10. *The Park Advisory Board recommends that the Planning Commission and the Board of County Commissioners include the following conditions when considering and/or approving the Paint Brush Hills Filing No. 14 Final Plat: (1) Provide to El Paso County a 25-foot trail easement along the northern boundary of Paint Brush Hills Filing No. 14 Final Plat, within Tract A, that allows for the construction, maintenance, and public access of the Arroya Lane Primary Regional Trail, and dedicate the aforementioned easement to El Paso County prior to the recording of the Final Plat; (2) The developer will relocate the proposed storm facility from Tact A to allow the trail to be constructed on the trail easement or provide the trail easement through lots 24-30.*

STREET IMPROVEMENT PLANS

PAINT BRUSH HILLS FILING NO. 14

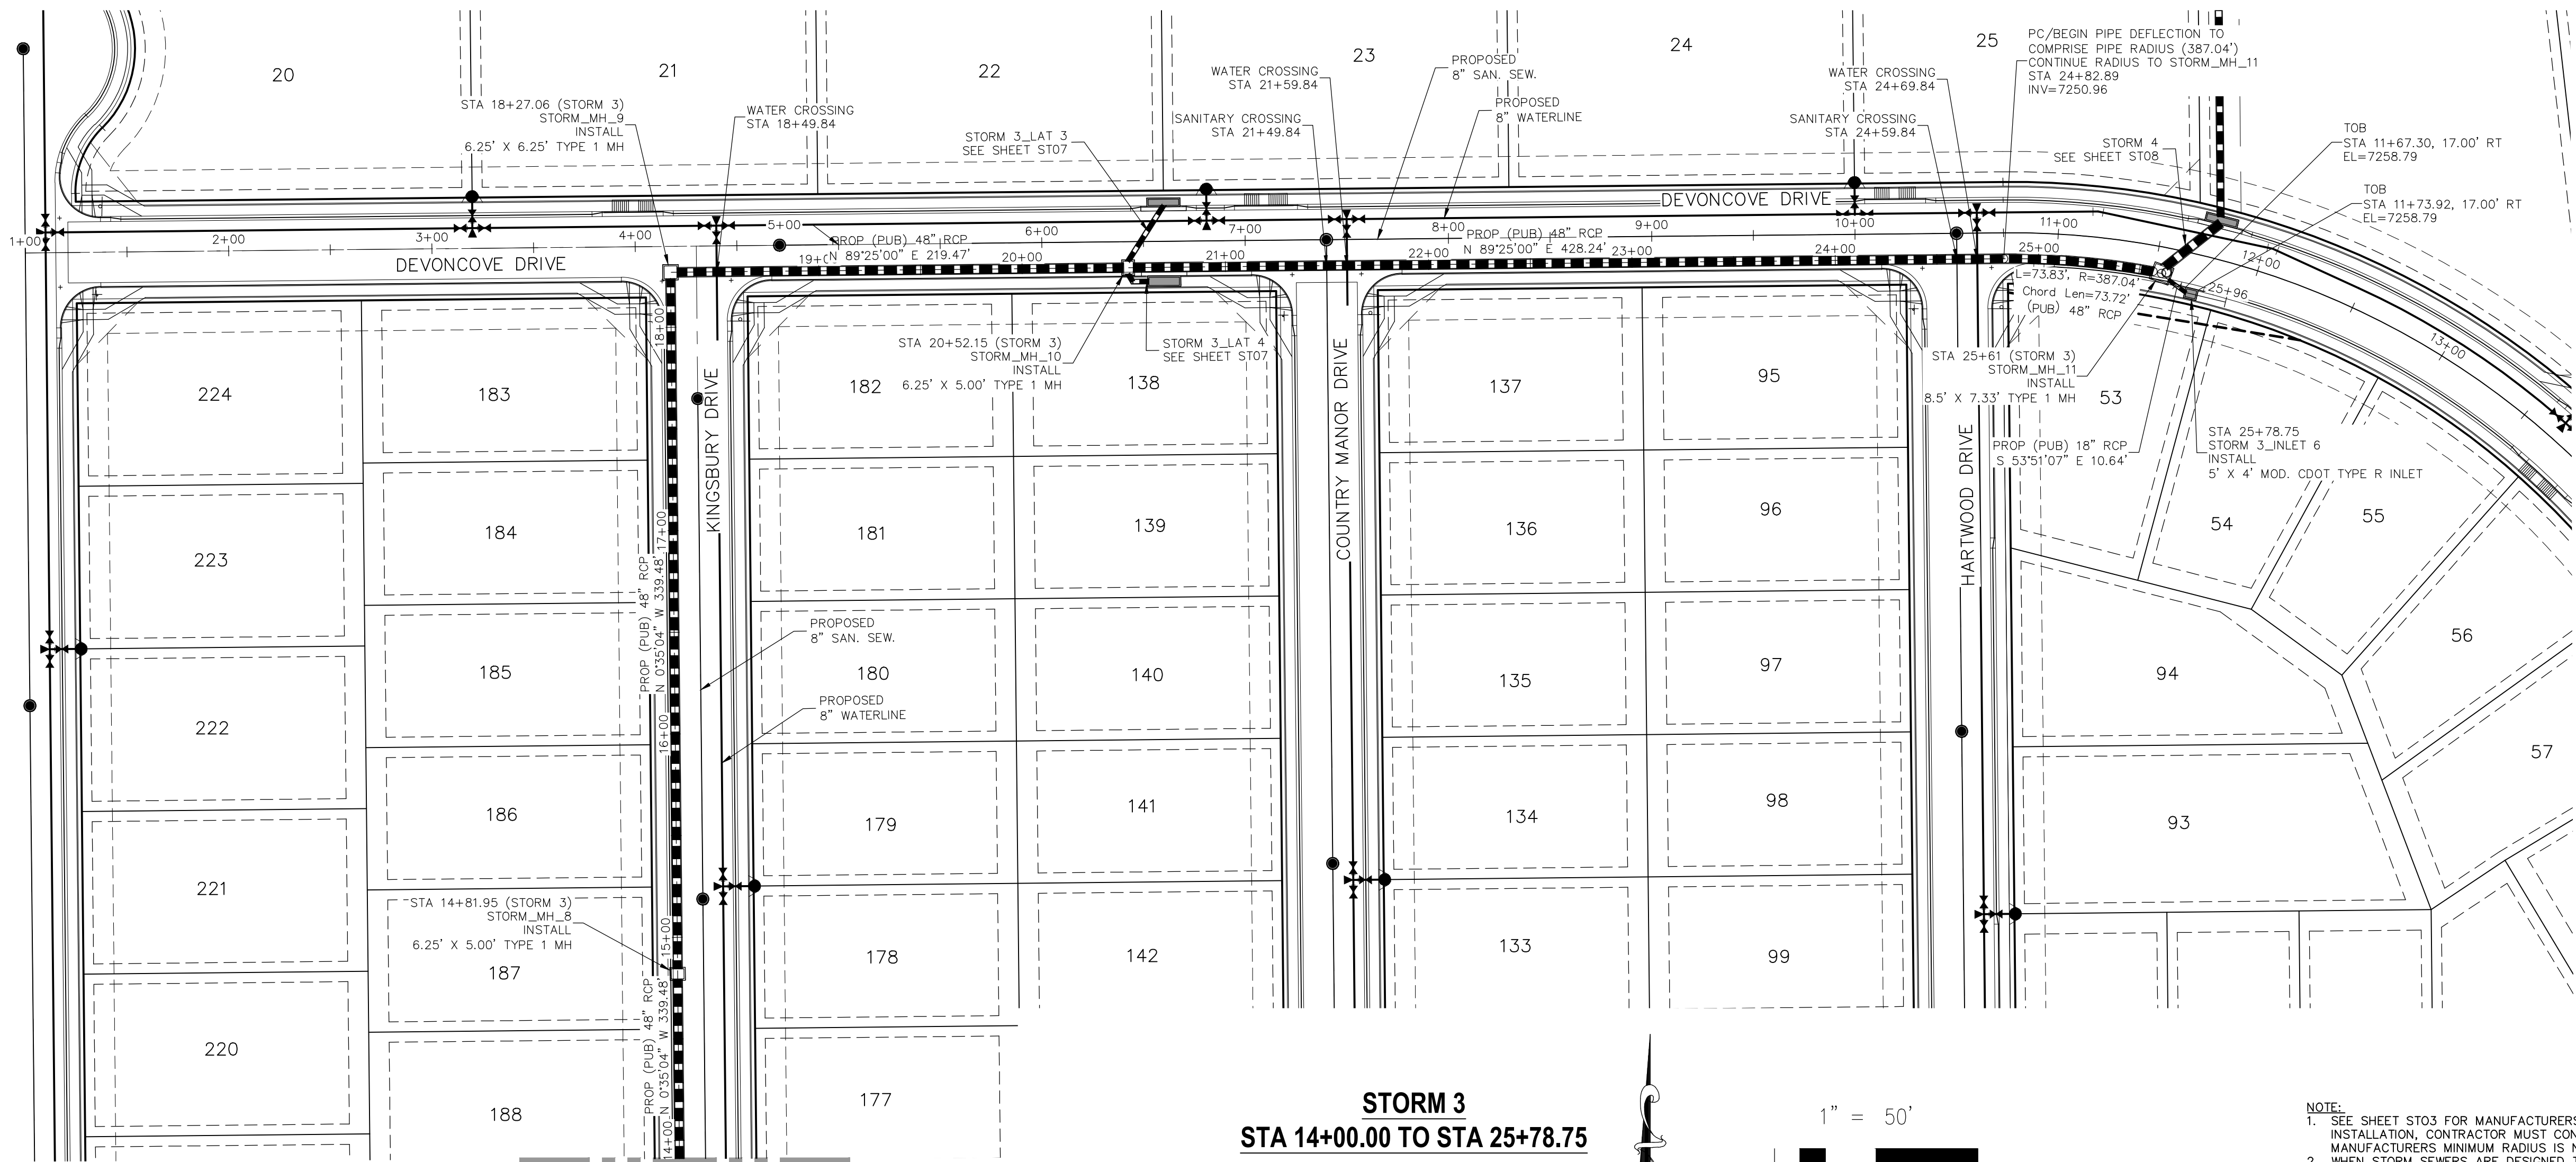
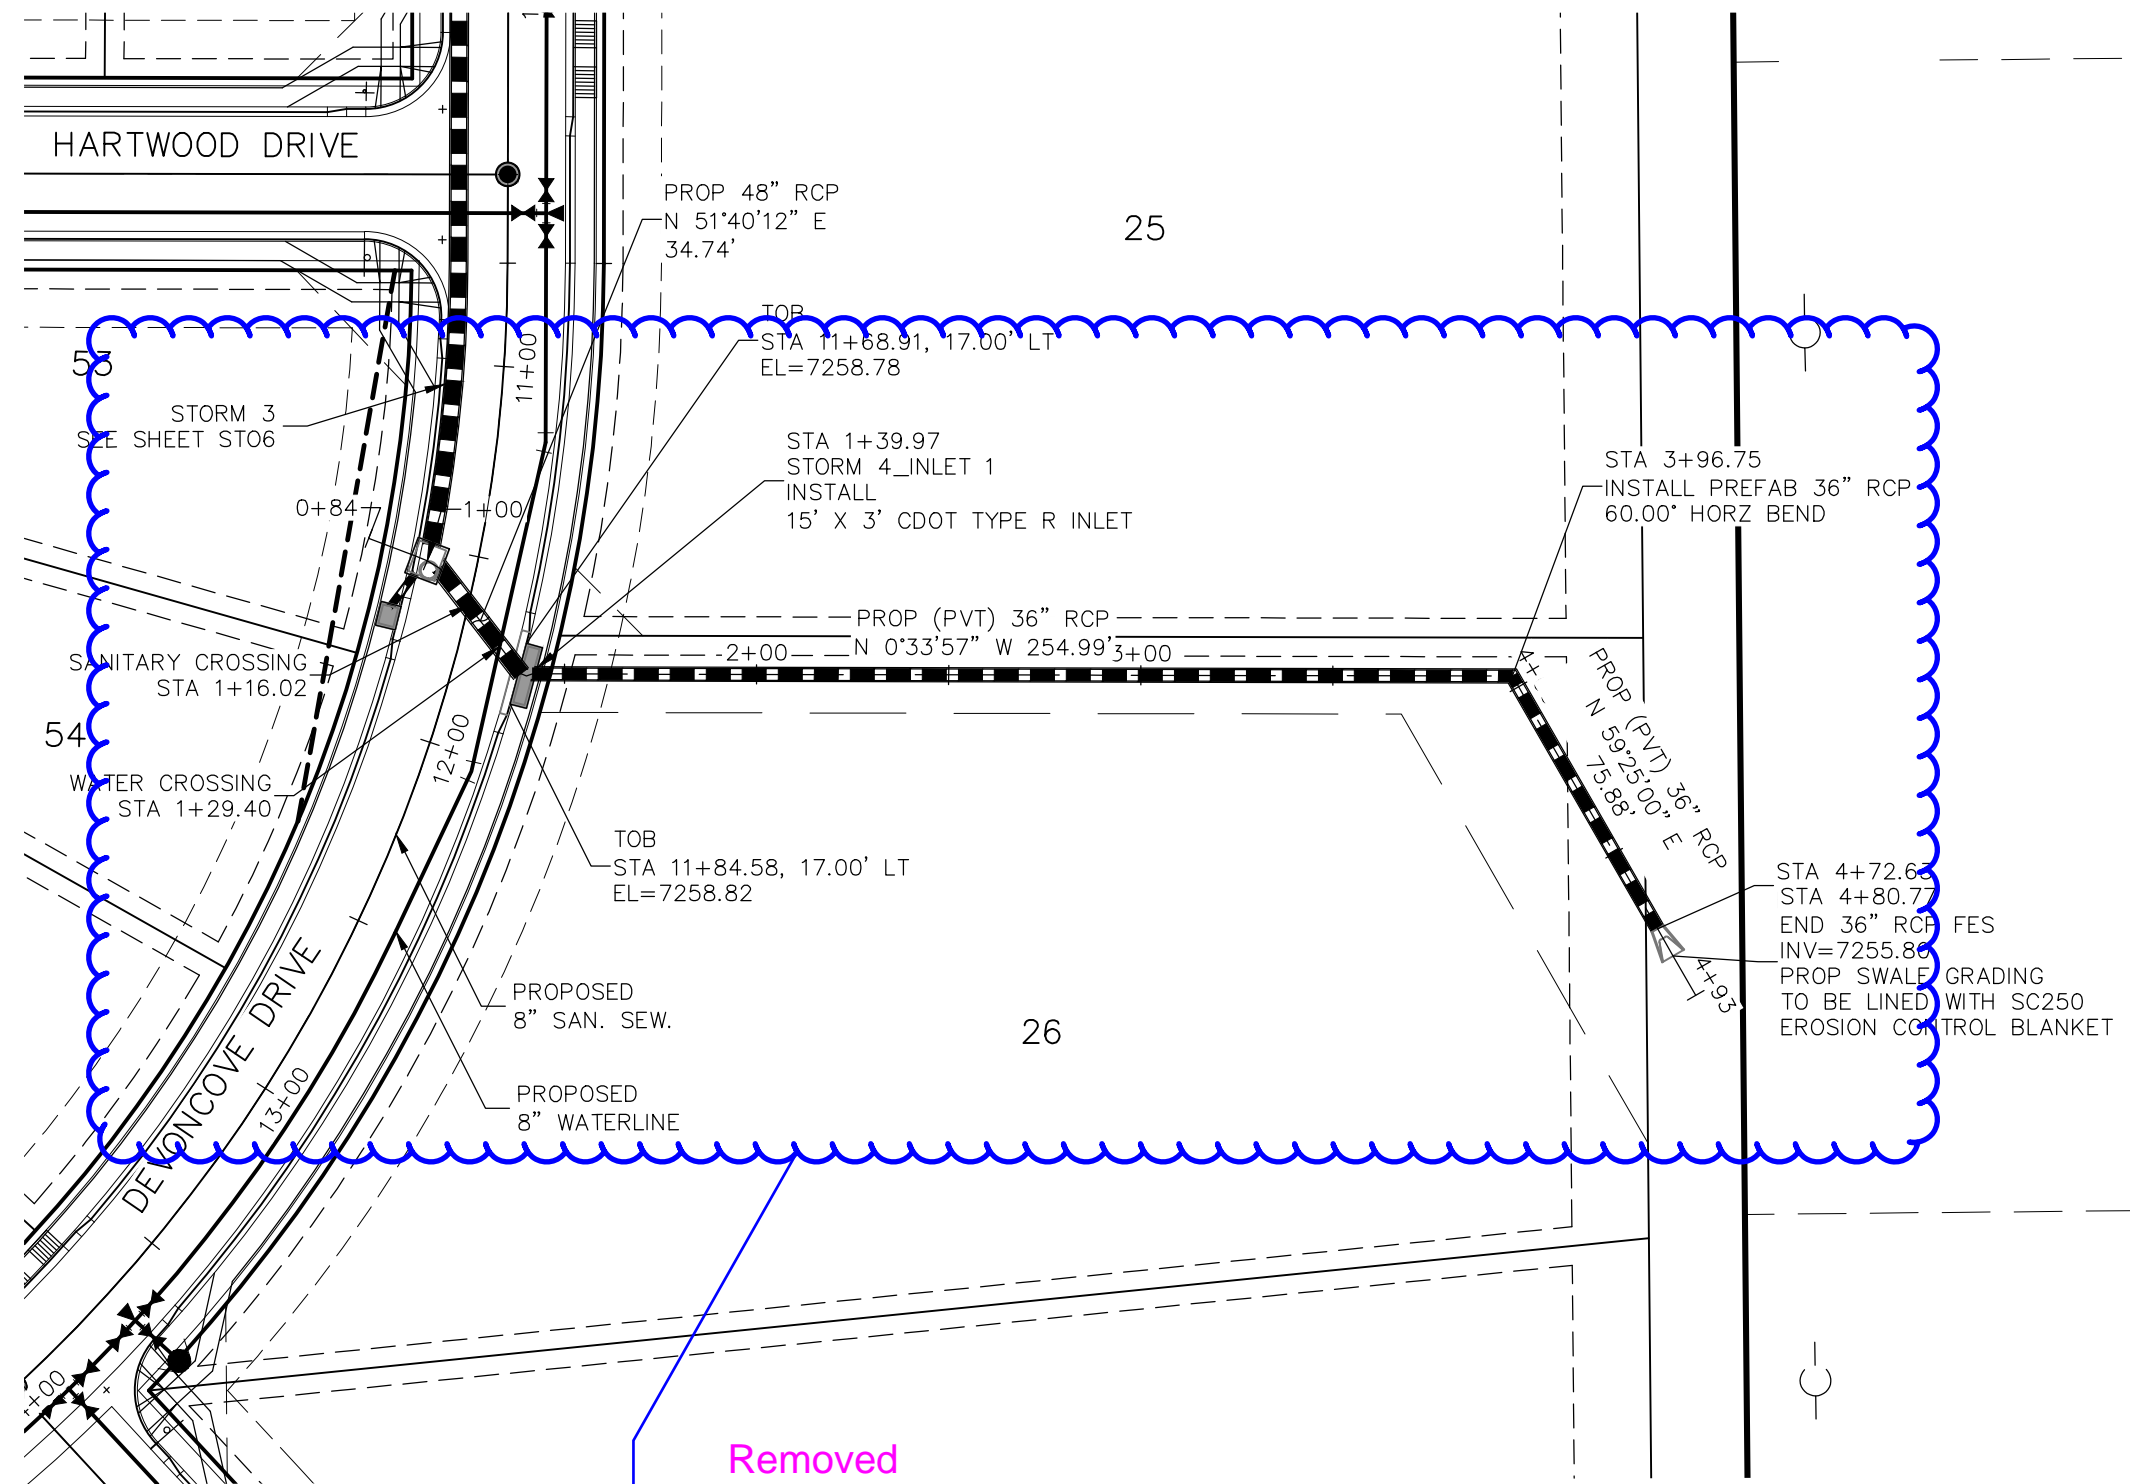
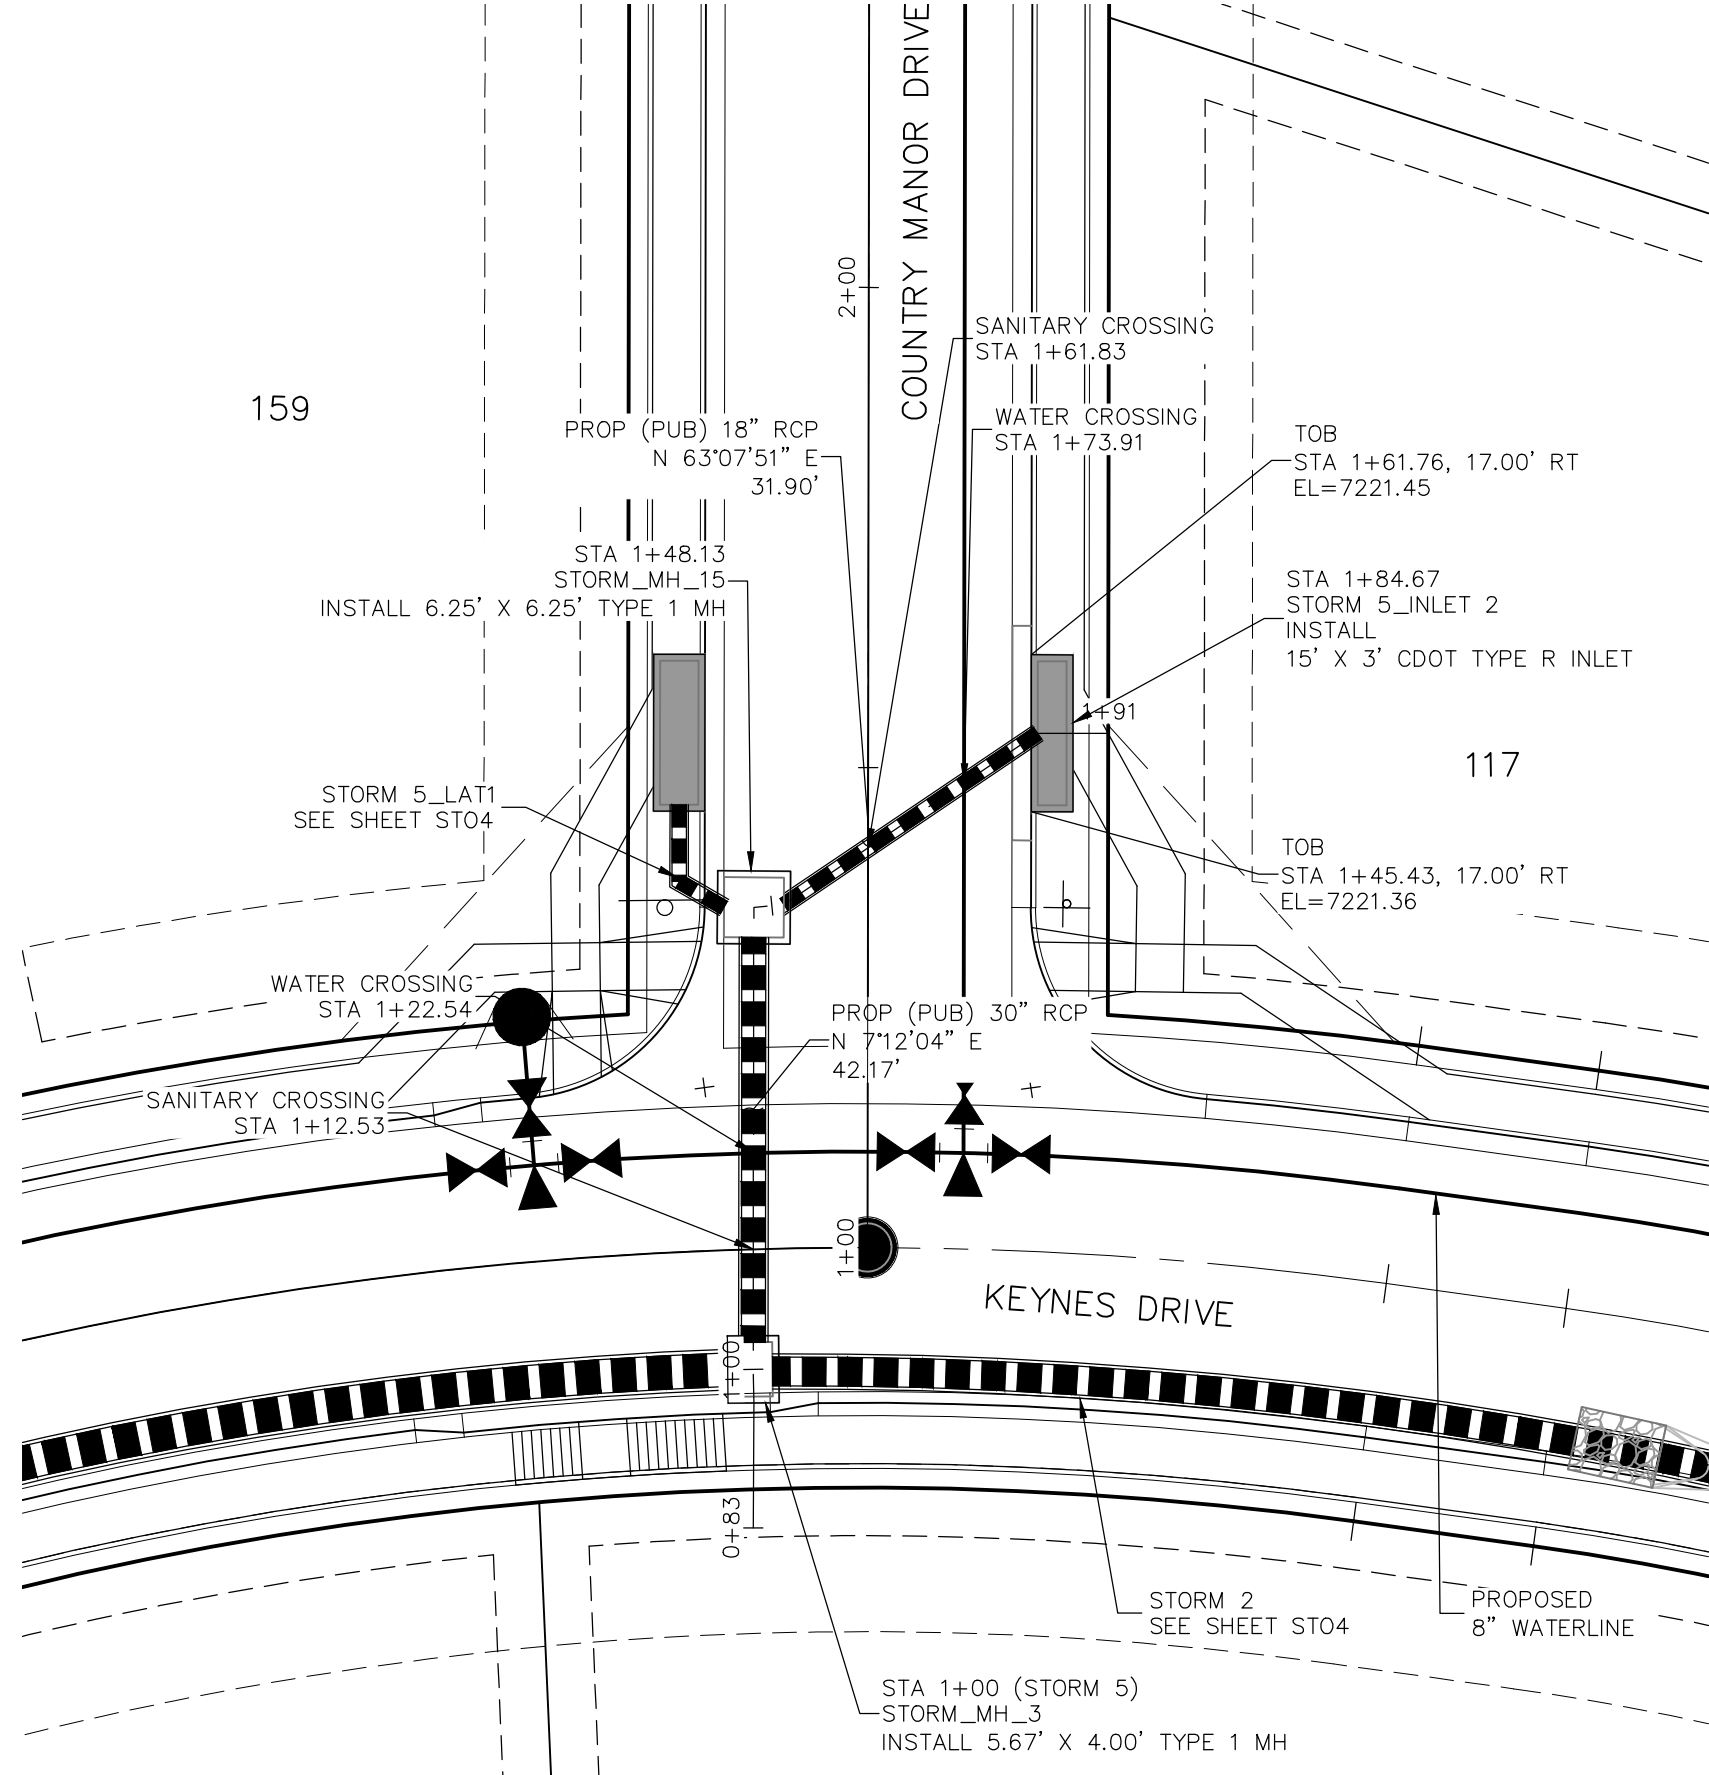
Reminder: Per design engineer, the storm system will be modified to address parks comments. Review on resubmittal. Make sure the associated drainage report is updated.
